Feature Update: Mudflap Hanger Bracket Fixturing

Feature Improved design of mudflap hanger bracket to prevent huck bolts from coming loose/breaking off

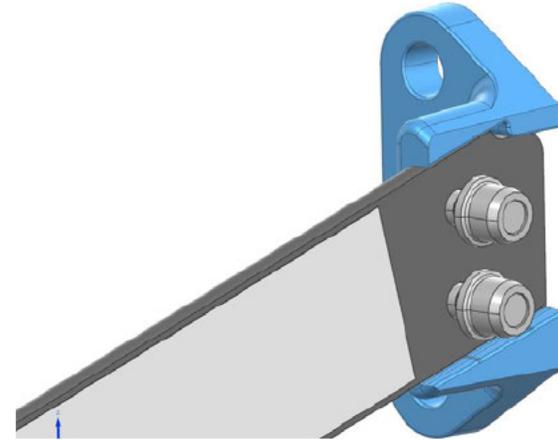
Description Prior design - significant part of clamp load goes into deflecting cast bracket to contact the hanger bar. Fasteners may loosen or break over time, requiring field-fix of installing grade 8 3/8" bolts w/ nylon locknut.

New design - bracket redesigned so that the cast ears do not have to be deformed to achieve clamping force on hanger
